**BOARD ACTION REPORT – APPEALABLE ITEM**

**Project Name:** 1125 Wallace Drive  
**Project Location:** 1125 Wallace Drive  
**Request:** Class V Site Plan Modification Landscape Plan, and Architectural Elevations associated with a self-storage facility.  
**Board:** Site Plan Review and Appearance Board  
**Meeting Date:** January 25, 2017

# SITE PLAN REVIEW AND APPEARANCE BOARD

ITEM: 1125 Wallace Drive – Class V Site Plan Modification, Landscape Plan, and Architectural Elevations associated with a self-storage facility.

**A1.00**

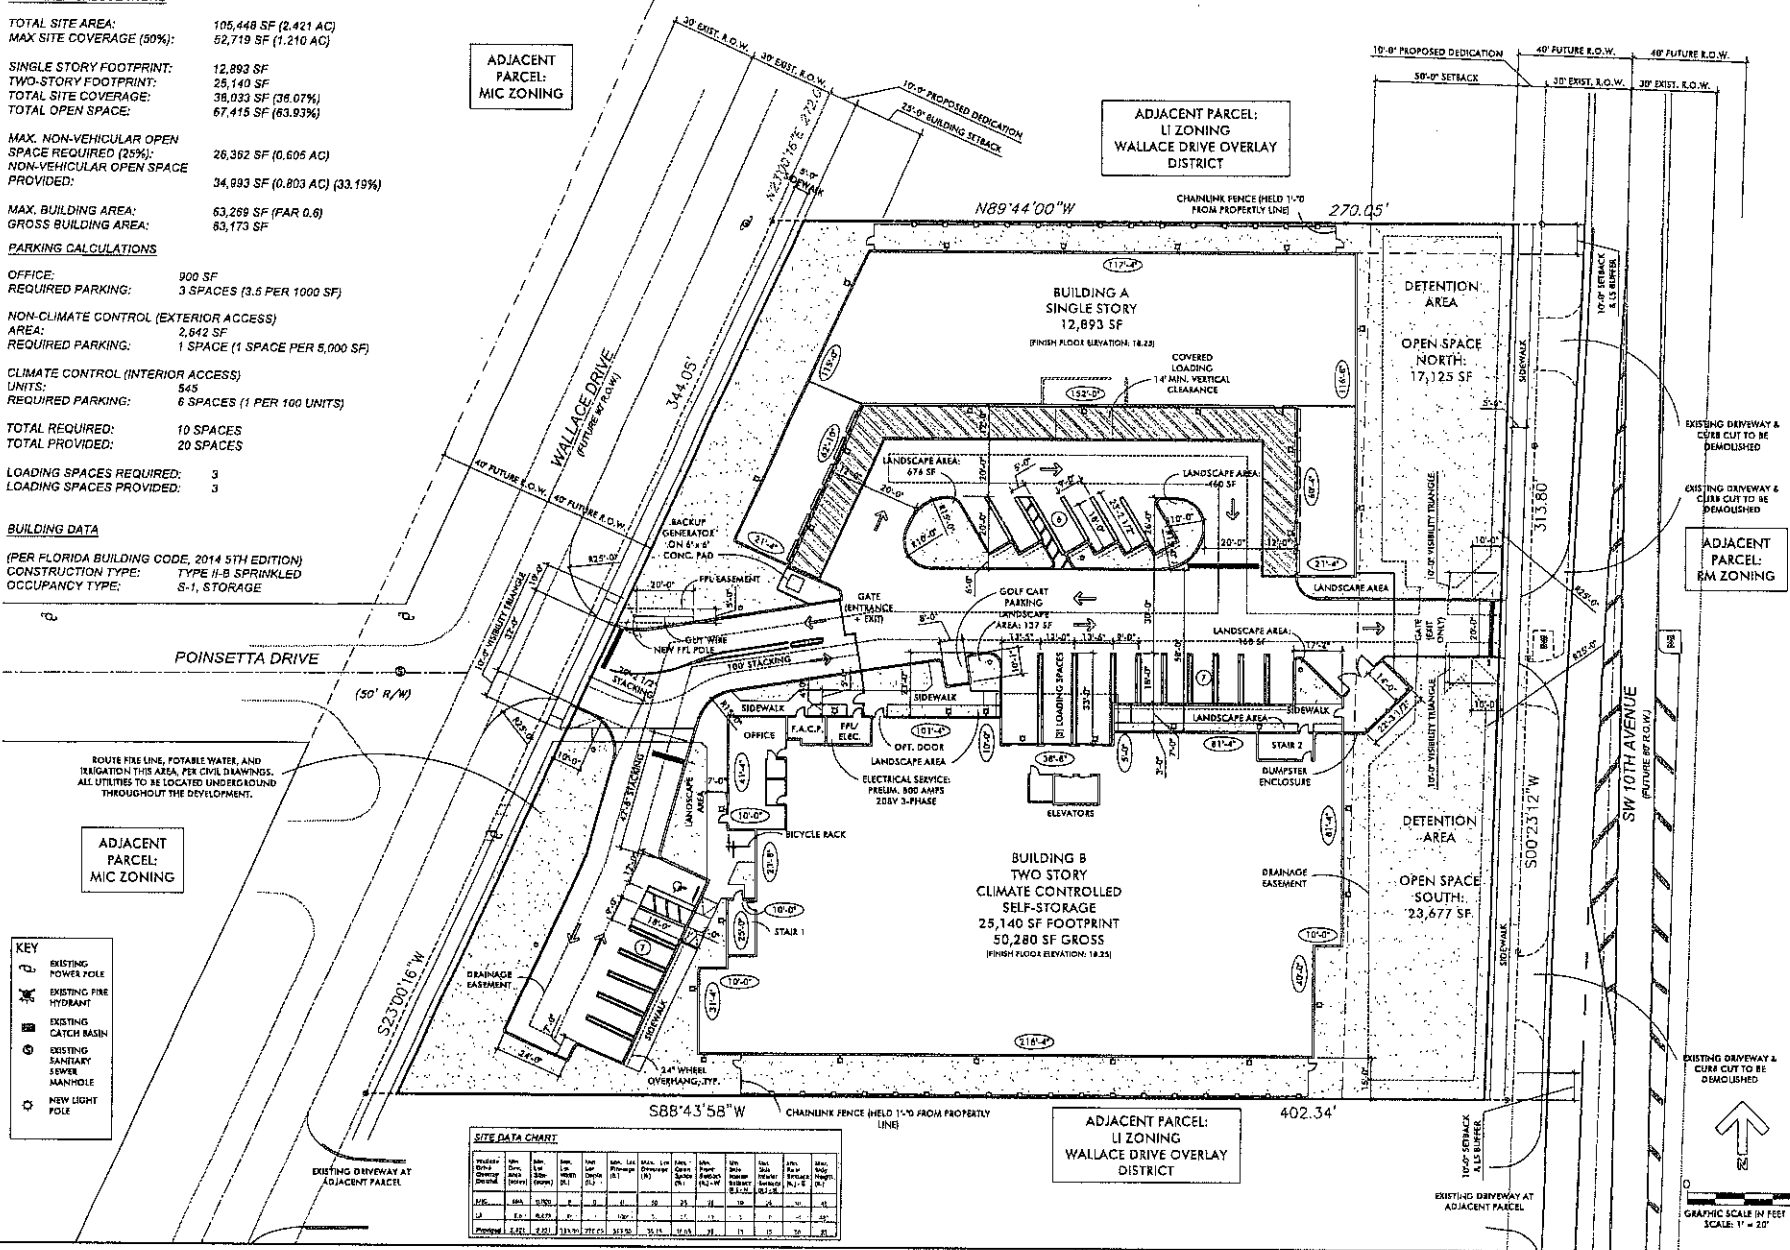
1. Update the site data chart on the site plan to reflect 10 ft. as the side interior setback on the south side. This is to be done prior to resubmittal for certification.
